### **CHILI'S RE-IMAGING, JSP13-23**

Approval of the request of GHA Architecture/Development for Preliminary Site Plan and Section 9 Façade Waiver. The subject property is located in Section 36 at 20901 Haggerty Road on the west side of Haggerty Road, north of Eight Mile Road in the OSC, Office Service Commercial District. The applicant is proposing to update the existing façade including repainting the brick, trim and metal screens and adding fabric awnings to the building.

## PLAN REVIEW CENTER REPORT

Re: **FACADE ORDINANCE - Facade Review – Final Site Plan**  
**Chili’s Reimaging, PSP13-0059**  
 Façade Region: 1, Zoning District: OSC

**RIGHT ELEVATION**

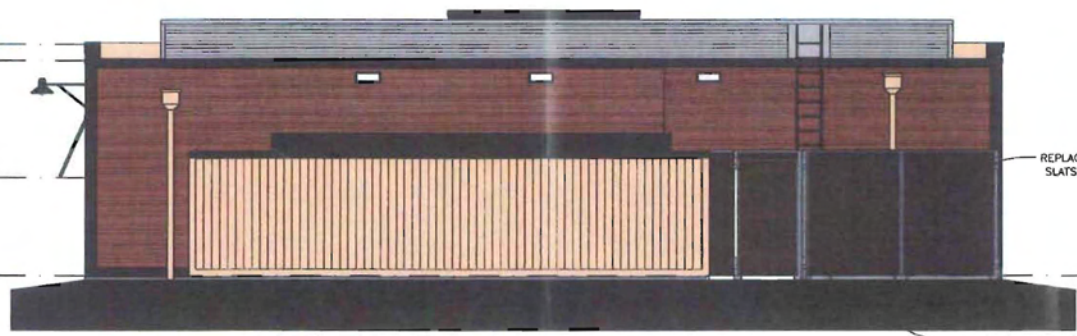
Accent (LED) Lighting – The renderings indicate “LED BORDER IN COVE” along the building’s parapet on all facades, and LED lights illuminating the awnings. This affect is not prohibited by the Façade ordinance providing it is integrated into the overall architectural design of the building with respect to color, intensity, and proportions. The applicant should clarify the color, intensity and method of integration of the LED lighting.

**Accent LED Lighting:** *The renderings indicate "LED BORDER in COVE" along the building's parapet on all facades, and LED lights illuminating the awnings. This affect is not prohibited by the Façade ordinance providing it is integrated into the overall architectural design of the building with respect to color, intensity, and proportions. The applicant should clarify the color, intensity and method of integration of the LED lighting.*

**Response:** Please refer to the enclosed LED Border Cove detail sheet and daytime and nighttime pictures of similar existing projects.

The LED border is mounted along the parapet profile and is shielded by a continuous aluminum cover to shine down to provide a wall wash effect. The aluminum cover is painted 'Dark Side' to match the parapet coping paint color. The color of the LED border or tubing is 'Orange'.

The existing goose neck lights (total 4) over the two front awnings are proposed to be replaced with new LED lights (total of 4) mounted to the bottom of the awning frame to illuminate the awnings. All other existing goose neck lights are to remain and painted 'Dark Side'.
